Change Notice Process Improvement B Series Toggles and BB Series Pushbuttons

Change in Sealing Method

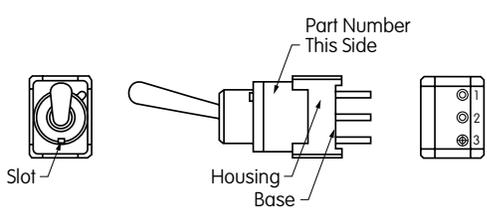
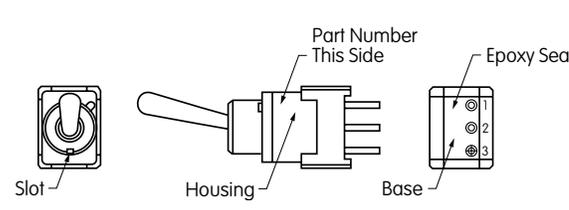
Before Change	After Change
 <p>Slot</p> <p>Housing</p> <p>Base</p> <p>Part Number This Side</p> <p>Ultrasonic Welding of Housing and Base</p>	 <p>Slot</p> <p>Housing</p> <p>Base</p> <p>Part Number This Side</p> <p>Epoxy Seal</p> <p>Epoxy Seal Applied to Base</p>

The change from ultrasonic welding to epoxy sealing affects all B Series Toggles, including custom switches.

The change from ultrasonic welding to epoxy sealing affects the BB Series Double Pole Momentary Pushbuttons, including custom switches.

B Series Toggles and BB Series Pushbuttons will be available with epoxy seal after **June 2006**.
